Access Compliance Report Public Rights-of-Way (Curb Ramps)

Main Street: ROSALIND_DR Cross Street: RAINIER_DR Location: NE

ADA ID: RPRK211006152451 Ramp Type: Type 1 - Perpendicular Diagonal Initial Pass/Fail: Fail Overall Compliance: No Severity Score: 15

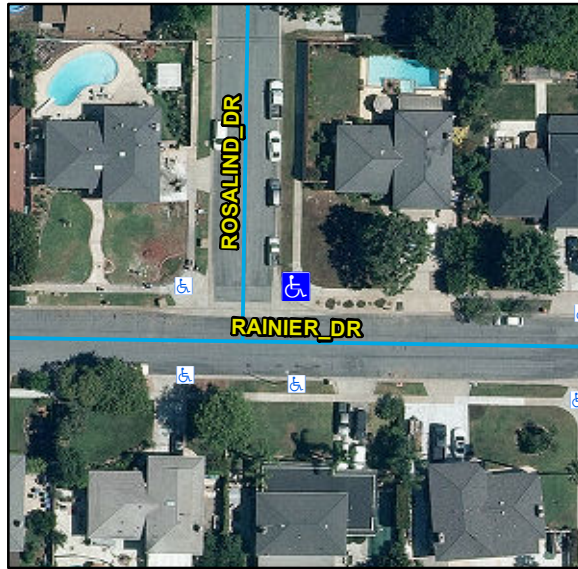
Compliance	Description	Data	Compliance	Description	Data
N/A	Ramp Length (in)	140	N/A	Flare Type LT	
Yes	Ramp Width (in)	48			N/A
No	Ramp Run Slope (%)	11.8	N/A	Flare Slope LT (%)	N/A
Yes	Ramp Cross Slope (%)	0.5	N/A	Flare Traversable LT	N/A
N/A	Landing Present	N/A	N/A	Flare Type RT	
N/A	Landing Length (in)	N/A			N/A
N/A	Landing Width (in)	N/A	N/A	Flare Slope RT (%)	N/A
N/A	Landing Run Slope (%)	N/A	N/A	Flare Traversable RT	N/A
N/A	Landing Cross Slope (%)	N/A	N/A	DWS Provided	N/A
N/A	Landing Movement Obstructed?	N/A	N/A	DWS Contrast	N/A
	Landing Movement Type	N/A	N/A	DWS Length (in)	N/A
N/A	Landing Shared	N/A	N/A	DWS Full Width	N/A
N/A	Clear Space	Yes	N/A	DWS Offset Left (in)	N/A
N/A	Clear Space To Crosswalk (in)	N/A	N/A	DWS Offset Right (in)	N/A
N/A	Marked Crosswalk 1	No	N/A	Marked Crosswalk 2	No
	Crossing 1 Direction	W		Crossing 2 Direction	S
	Marked Crosswalk 1 Width (in)	N/A		Marked Crosswalk 2 Width (in)	N/A

N/A	Ramp Inside Crosswalk 1	N/A	Yes	Ramp Inside Crosswalk 2	N/A
	Crossing 1 Slope (%)	6.1		Crossing 2 Slope (%)	3.3
	Crossing 1 Cross Slope (%)	3		Crossing 2 Cross Slope (%)	0.7
N/A	Gutter Ponding	N/A	No	Curb Slope	12.8
Yes	Gutter Lip Height (in)	0		Road Run Slope (%)	3.9
N/A	Gutter Run Slope (%)	N/A		Road Cross Slope (%)	4.1
N/A	Gutter Cross Slope (%)	N/A			
Yes	Overall Surface Condition: Acceptable		No	Perp Joint Present	No
	Cross Gutter Present?	Yes		Spandrel Present?	Yes
	Replace Cross Gutter?	No		Replace Spandrel?	No

Remove & Replace Curb Ramp With Two New Directional Ramps or Equivalent.

R304.2.2, R204.3, STD 1115
